DRAINAGE LETTER

WATER TREATMENT PLANT BUILDING ADDITION

SECURITY WATER DISTRICT

PROJECT NO. 2022-076.130

**FIGURE IV-3
PROPOSED MINOR DRAINAGE BASIN
SECURITY WATER DISTRICT**

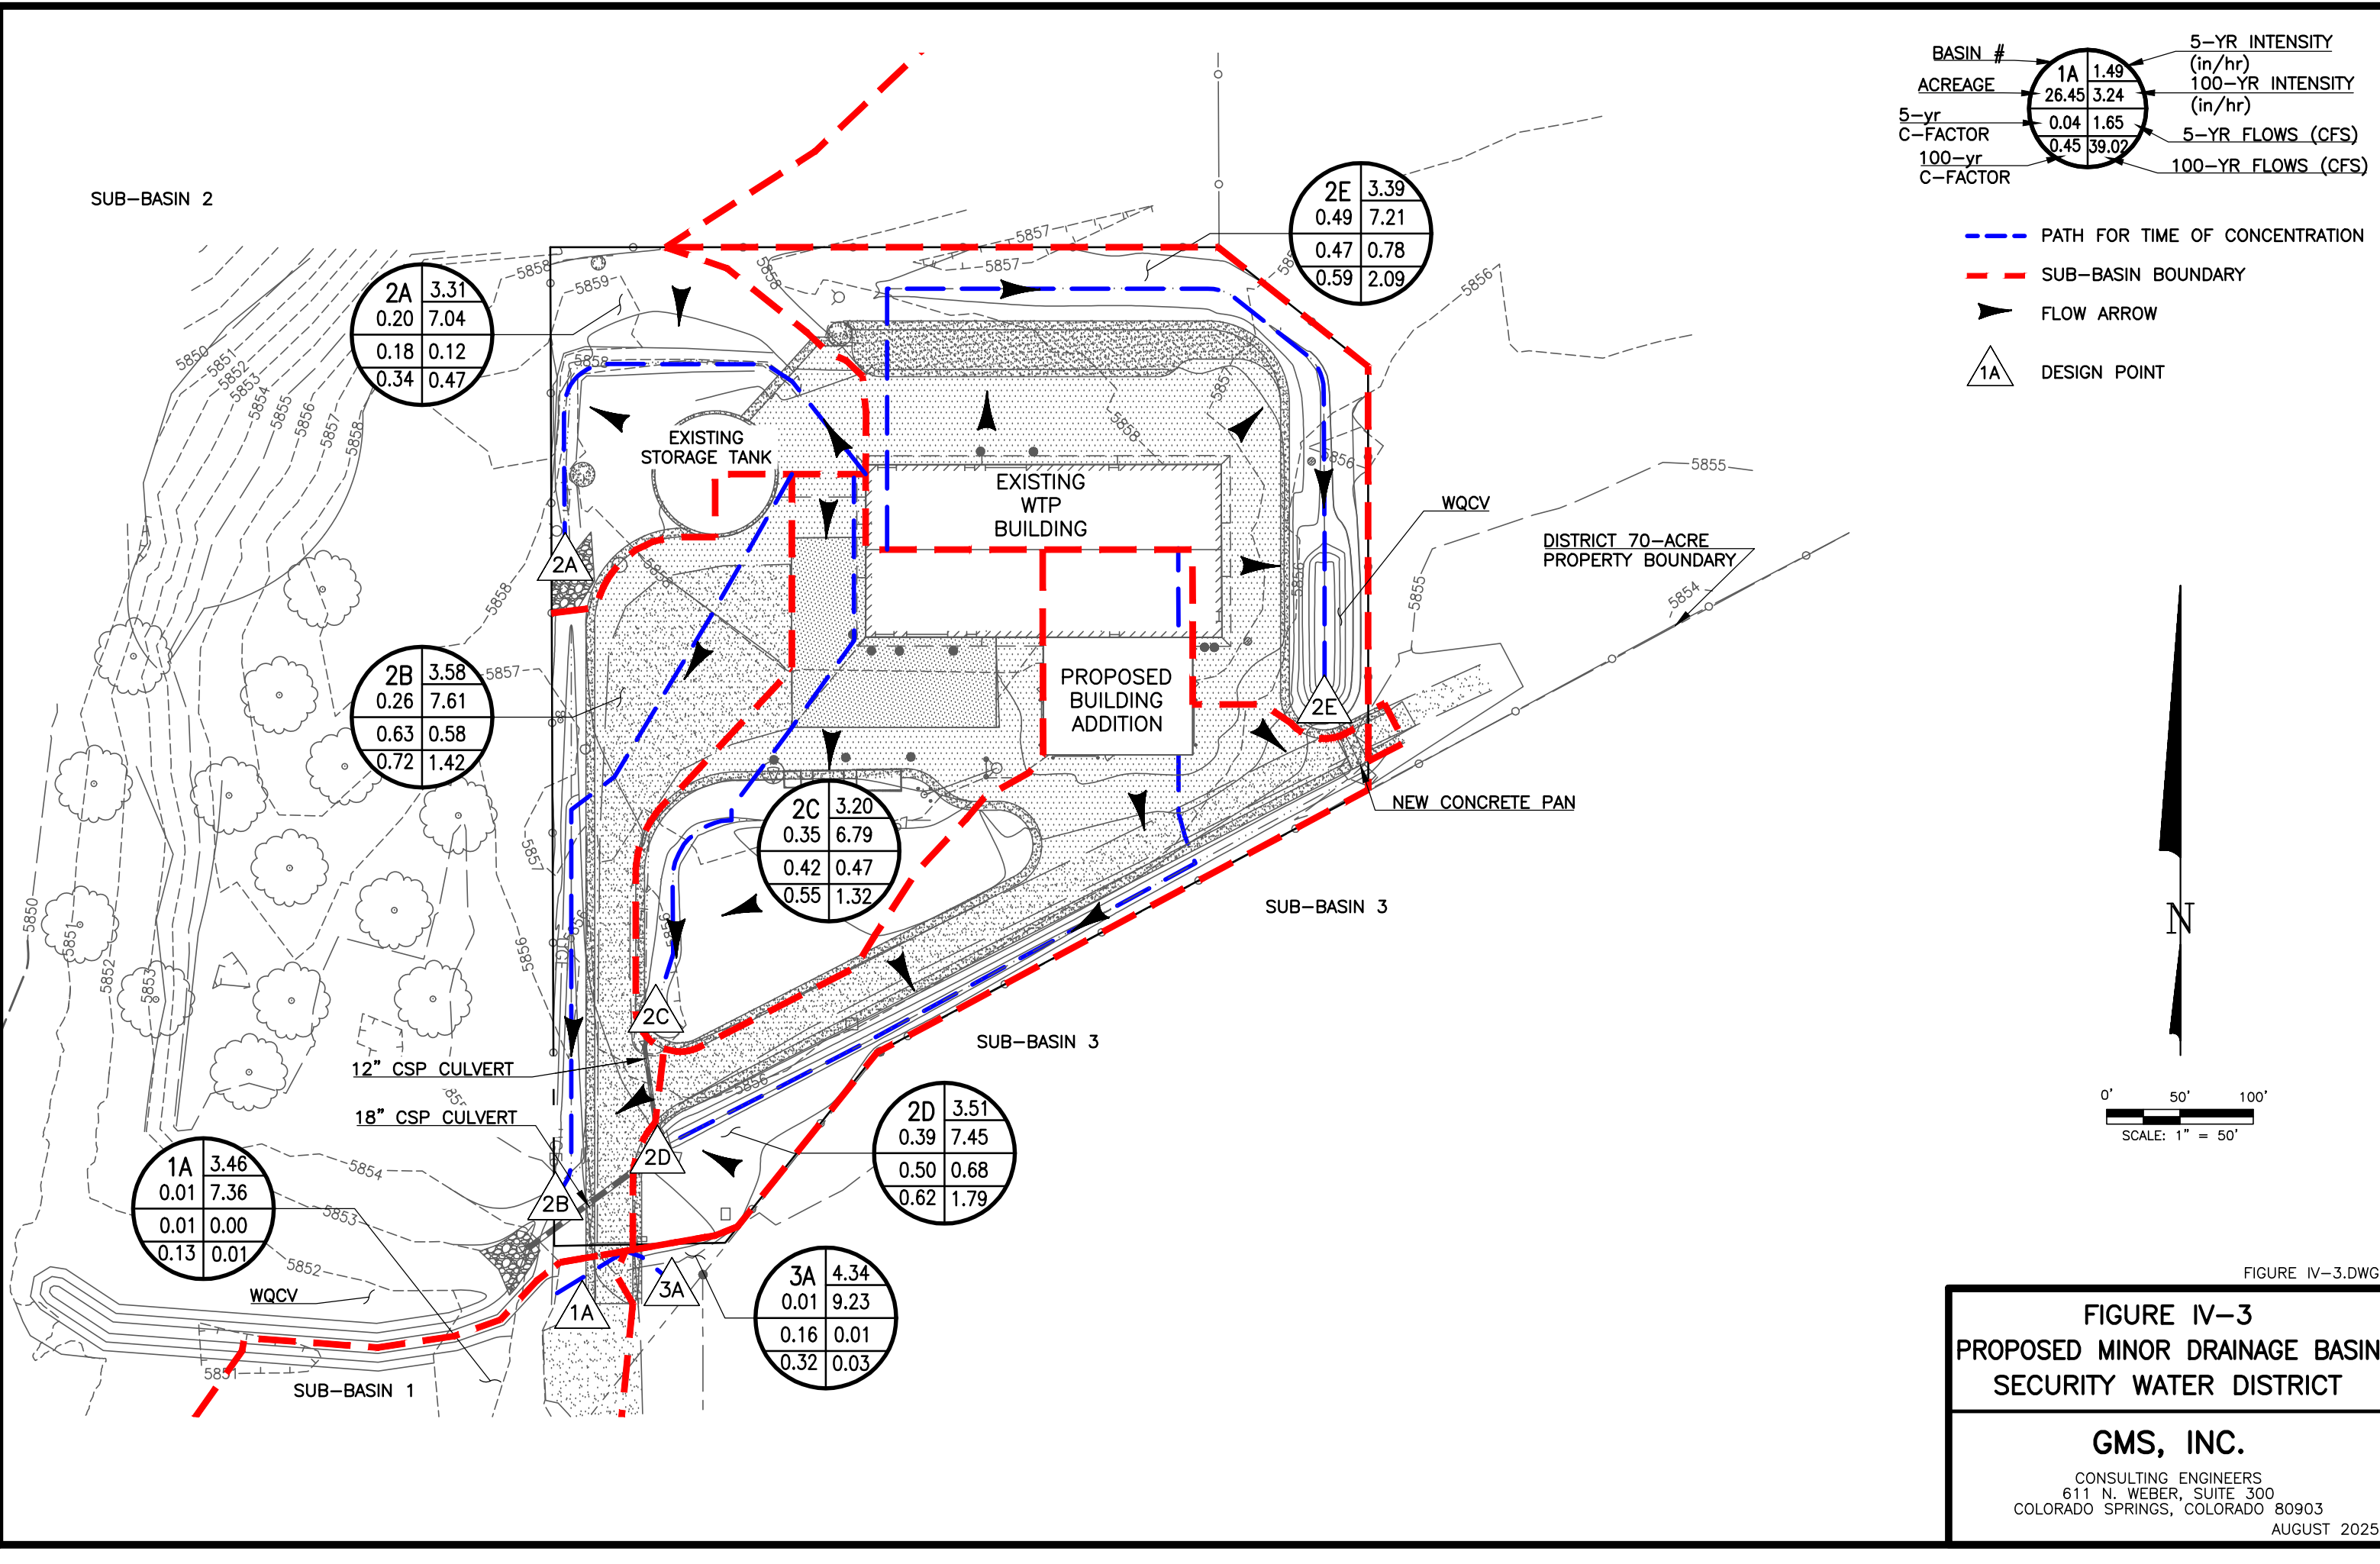
The current proposal intends to divert flows from sub-basins 1 & 3 to sub-basin 2.

Flows that used to run off site would now be infiltrated/evaporated, which the state tends to oppose based on past projects.

Please provide confirmation/correspondence with the state that indicates that they approve this approach.
